MANN-FILTER

Product Information

No 120
06/03/2017

The cabin air filter CUK 2940 in a new Design!

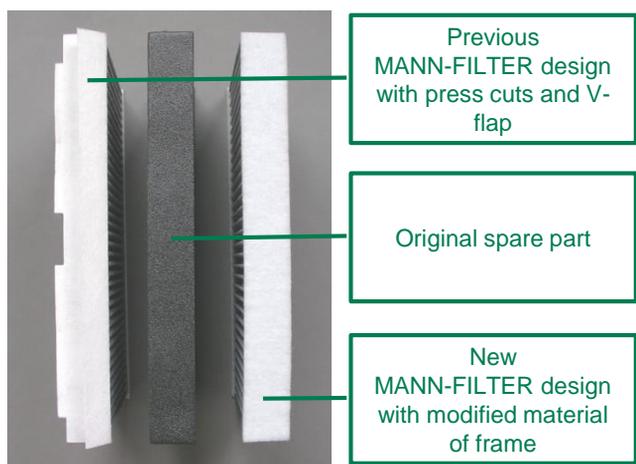
The cabin air filter CUK 2940 has been changed in design. Due to that it now visually differs from the predecessor.

The material of the frame at the longitudinal side of the CUK 2940 has been changed. Therefore the original press cuts and the V-flap can be removed.

A change in design has been made to the original spare part. According to that the CUK 2940 has also been adapted.

The new material of the frame at the longitudinal side still cares for an optimal sealing in the filter seat.
